PowerWater

APA Gas Pipeline LFI Mitigation Review

March 2014

Figure 26: LFI Darwin City Gates to Manton with (Fault at Manton) (SPS Result)

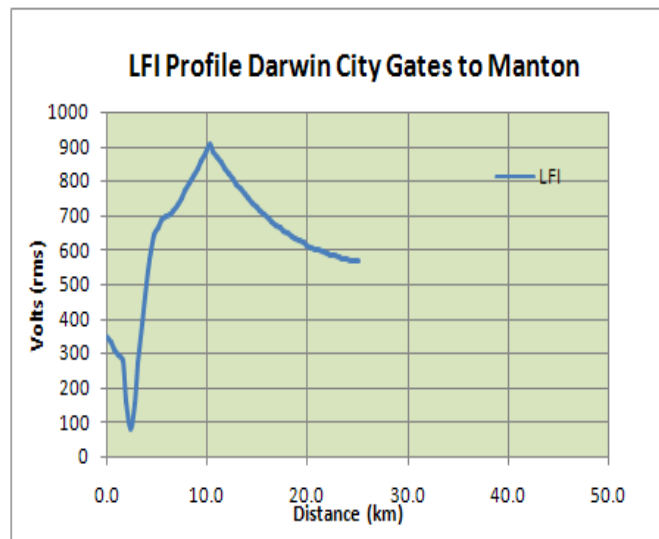
With the transmission line geometry shown in Figure 25 and using ‘Grape’ Phase conductor’s plus ‘Almond’ Earth Wire) the Phase to Ground fault current at Manton is 2.1kA which is consistent with the PWC result. There is a small contribution from Pine Creek to this 2.1kA. Therefore the fault current contribution sourced from Channel Island is approximately 1.9kA.

In the GCA study a value of 2.6kA has been used and it is assumed that this is totally sourced from Channel Island. This is therefore a slightly inflated value. Nevertheless in order to validate the GCA result based on the data used the fault current contribution from Channel Island was adjusted to equal 2.6kA by lowering the source impedance. In this way the results using similar input data can be compared. Figure 26 shows the pipe line voltage profile generated by the SPS model.

Figure 27: LFI Darwin City Gates to Manton with a Fault at Manton (GCA Result)

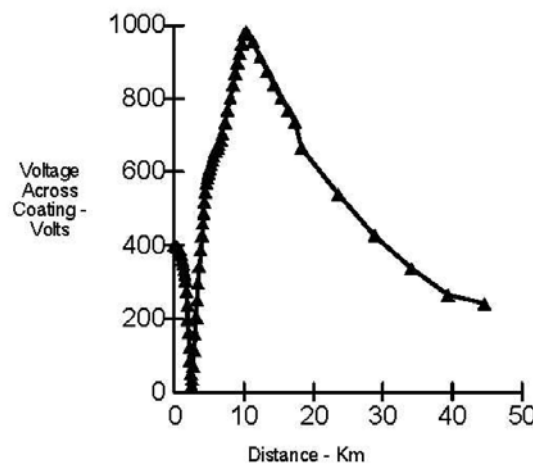
Figure 27 shows the pipe line voltage profile presented by GCA. The SPS and GCA results are quite similar sharing almost the same general shape. The SPS maximum voltage is slightly lower than the GCA result but given the possibility of slight differences in the model data definition especially associated with the Pipeline impedance our opinion is that there has been reasonable verification of the result and therefore the background calculation algorithms.

Figure 28: Darwin City Gate to Manton LFI (Fault at 5.5km from City Gate) (SPS Result)

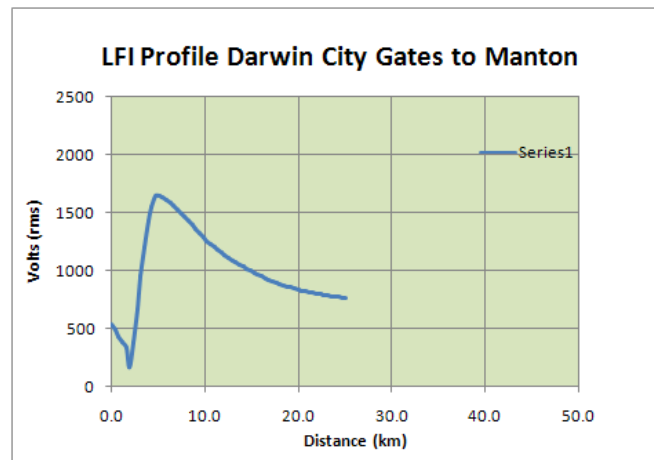
The SPS being a full Network model has the flexibility of being able to move the fault to alternative locations and obtain other LFI profiles. In this way the worst case can be found. Figure 28 shows the LFI profile for a fault at a location 5.5km from the Darwin City Gate.

The fault current is now 6.5kA based on the same source impedances which gave a fault level of 2.6kA at Manton. The maximum LFI voltage has now increased by nearly 80%, mainly due to the fault current increasing by 150%. The LFI increase is restricted to a lower proportion due to some of the fault current being sourced from Pine Creek via Manton.

Figure 29: Katherine Lateral LFI Voltage Profiles (note secondary scale for 2.2kA fault)

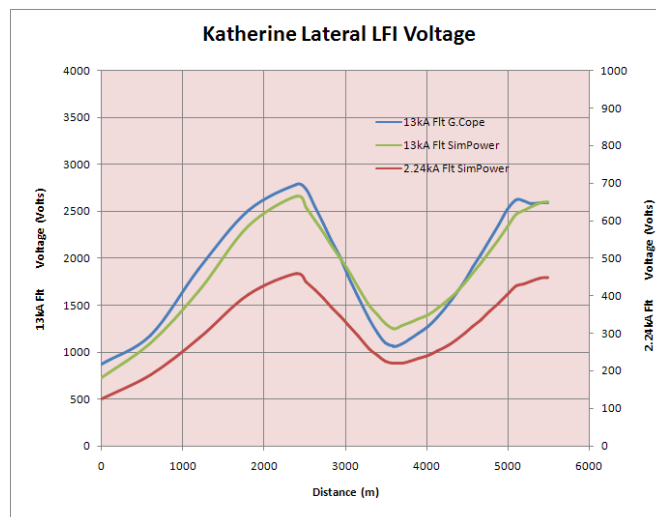
Figure 29 shows the result which was obtained with the GCA result also being plotted on the same scale. The SPS and GCA results are very similar which validates the later calculations based on similar input data. The maximum LFI voltage level which is slightly greater than 2500V is very high and GCA have dismissed any further analysis or Risk assessment and have concluded that mitigation at assessable points will be required. For the Katherine Lateral this will be all the CP test points and the Katherine take off site on the main APA pipeline.

However in this analysis the fault level is expected to be much higher than reality. To test this view a fault was applied in the same location but with normal source impedances. The result was a phase

to ground fault current of 2.2kA at the 5.5km point. The LFI voltage profile is correspondingly lower being a maximum value of just over 450V. This is dramatically lower and on this basis we would question the validity of moving directly to the Mitigation process without conducting a more rigorous study and based on this a Quantitative Risk Analysis.

Figure 31: Pipeline CP Point Equipotential earth mat

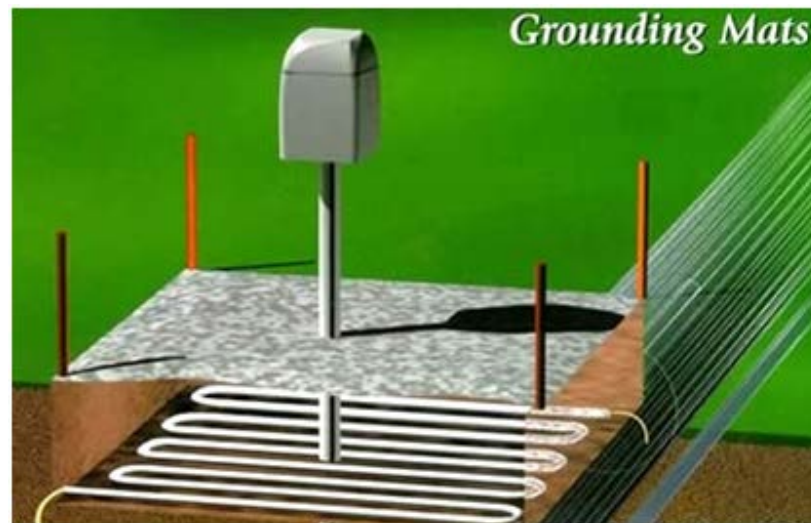
The GCA report recommended mitigation strategy is to deploy equipotential grading rings at the CP test points in areas where the modelling has indicated high LFI voltage levels. Figure 31 shows a typical installation. It consists of a buried mat which is connected to the pipeline under fault conditions. The area on the soils surface directly above the mat is tied to the pipe potential and therefore personnel working on CP test points are never exposed to the pipeline potential relative to the remote earth. The units suggested by GCA are a different design; however the principle is the same.
